Preservation Department – Item 1, LPC-22-08731

**6301 12th Avenue, aka 6301-6323 12th Avenue, 1202-1216 63rd
Street, and 1201-1215 64th Street – Angel Guardian Home –
Individual Landmark
Borough of Brooklyn**

LPC-22-08731: 6301 12th Avenue, Angel Guardian Home - Individual Landmark

PUBLIC MEETING SCOPE 09/20/2022

**12TH AVENUE
PROPOSED ELEVATION**

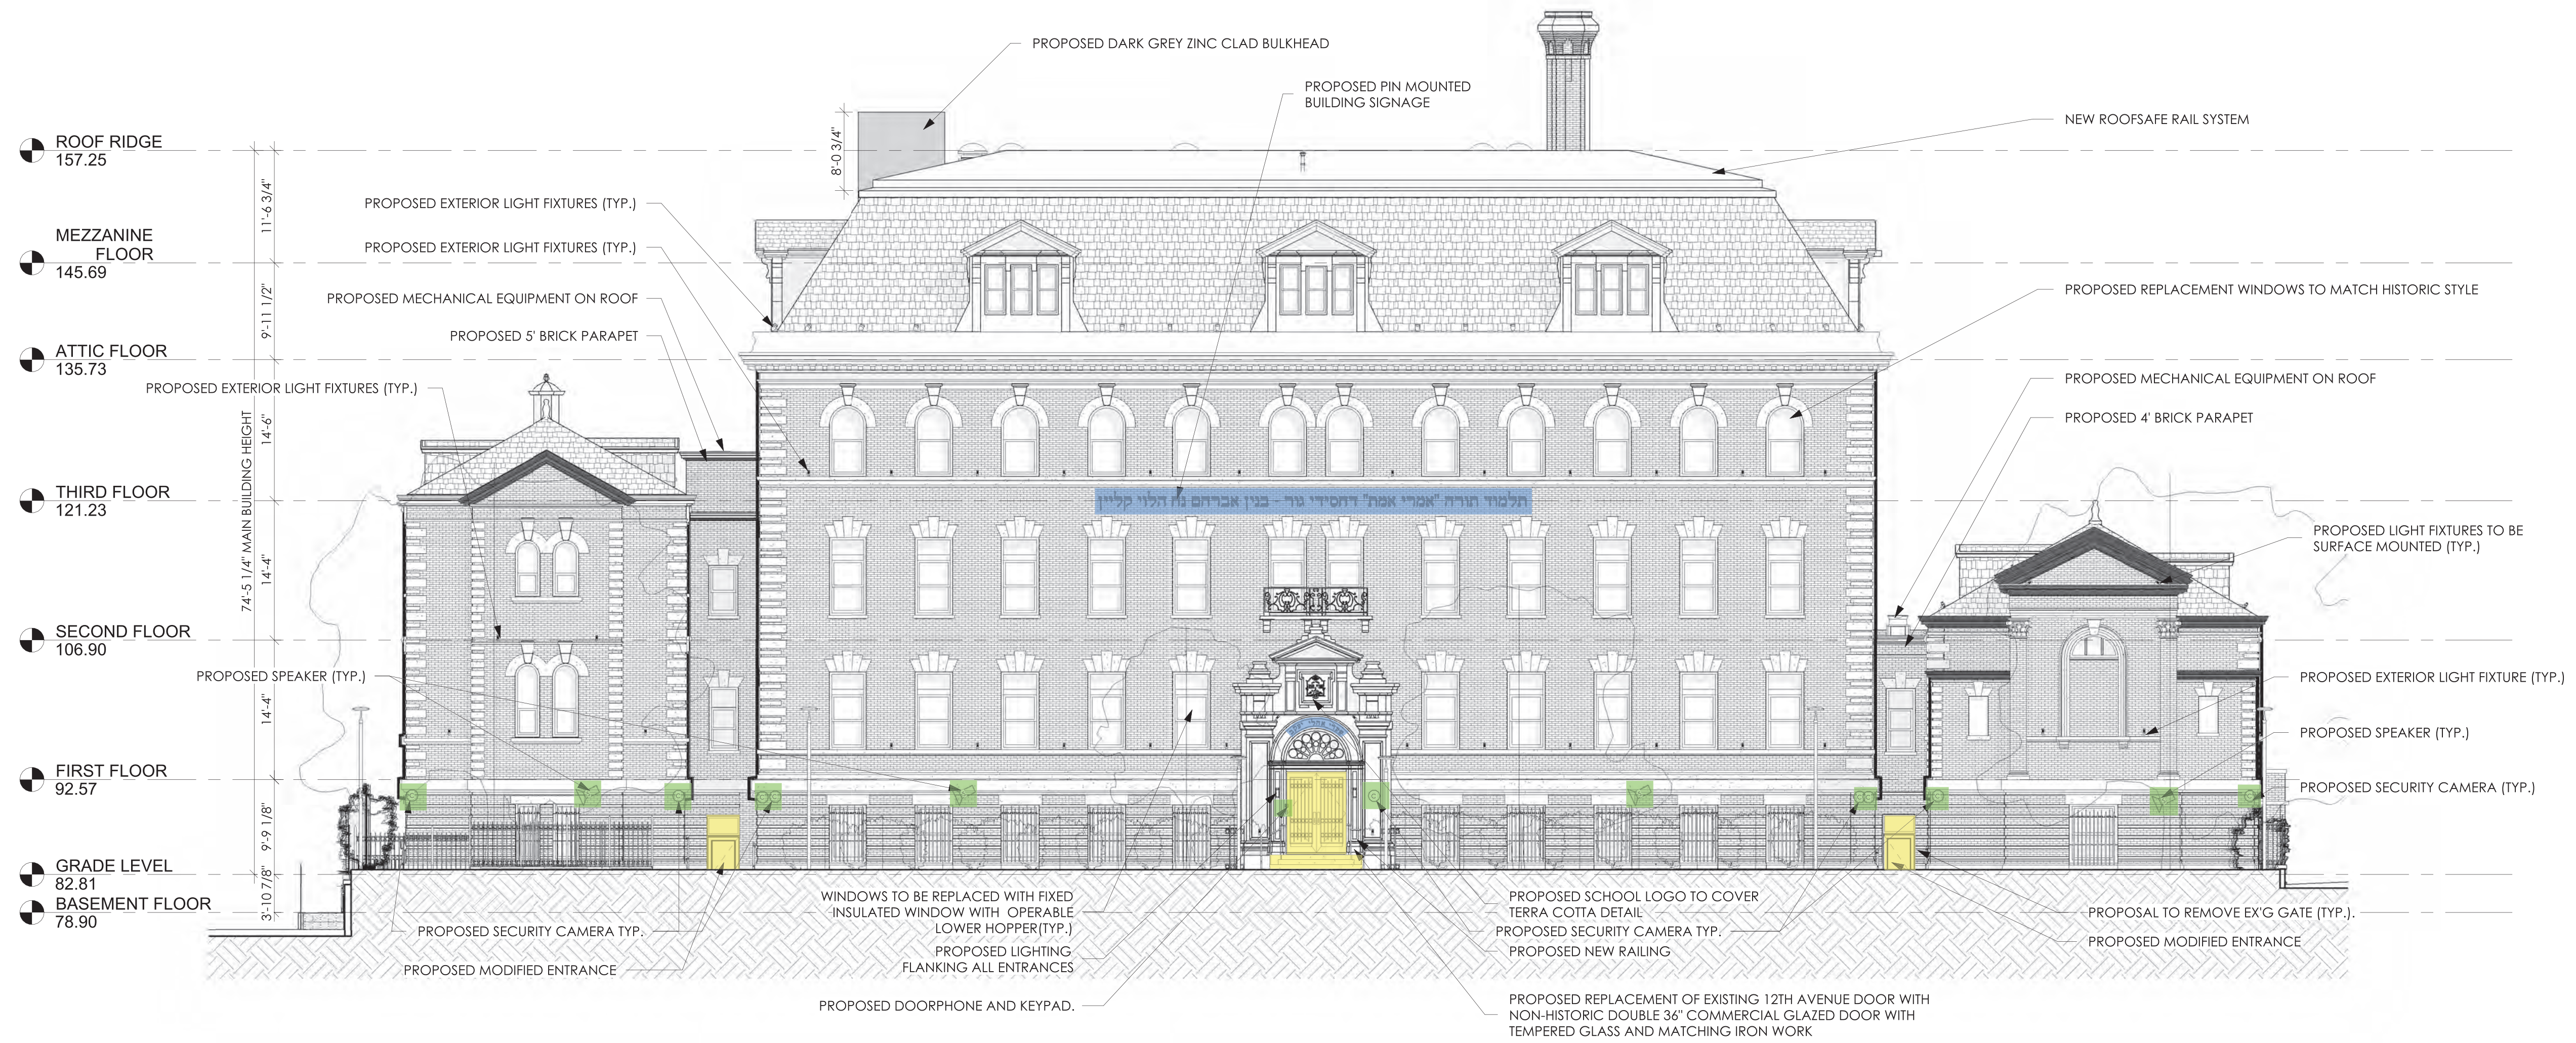
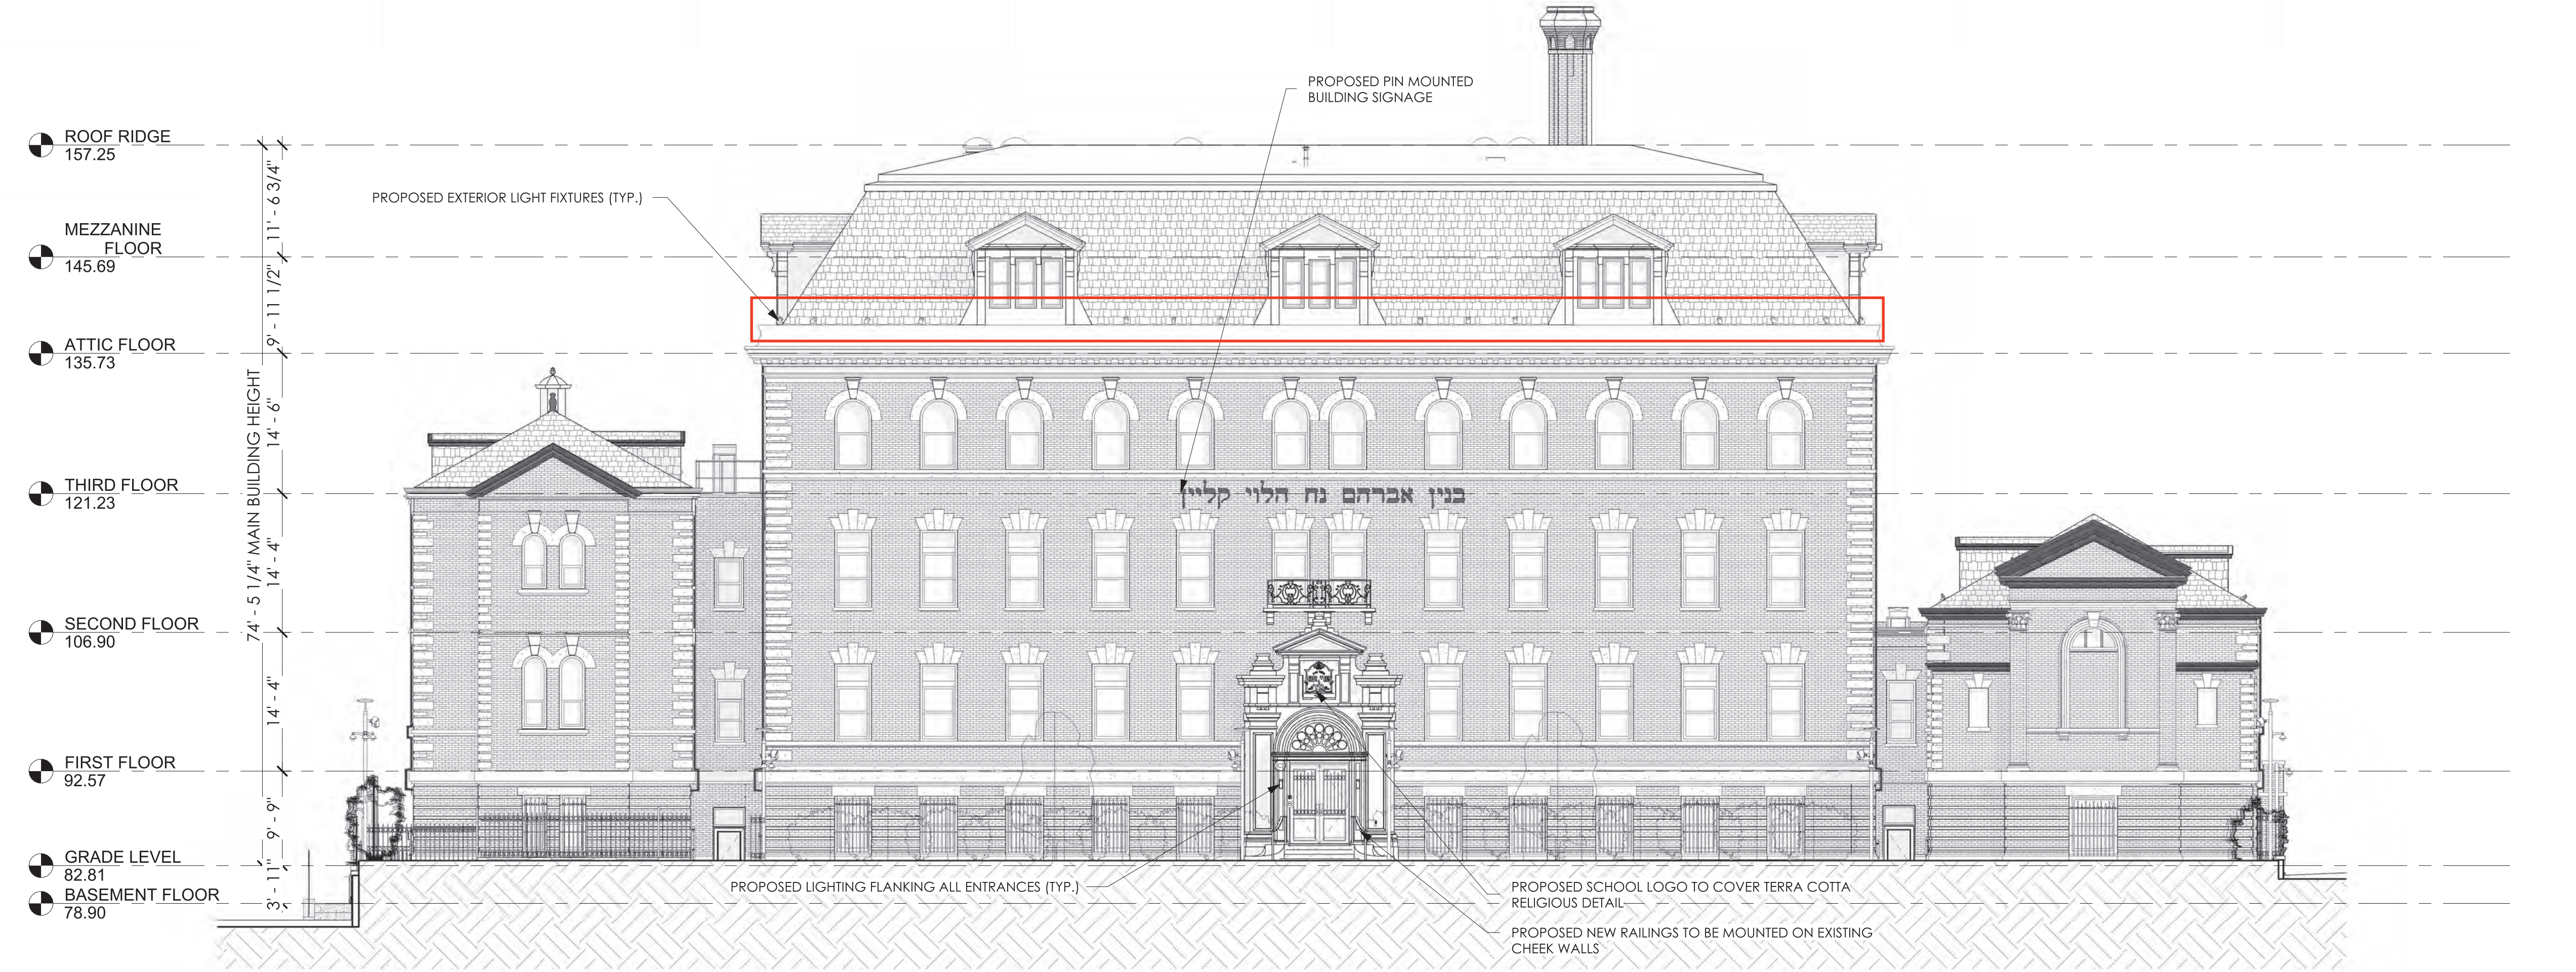
- CHANGES:**
- LIGHTING, SPEAKER, AND SECURITY CAMERA FIXTURES REMOVED
 - DOORS REVISED TO MATCH HISTORIC IMAGES
 - LETTERING ON ARCH REMOVED
 - LETTERING ON FACADE SHORTENED
 - ELEVATOR BULKHEAD LOWERED
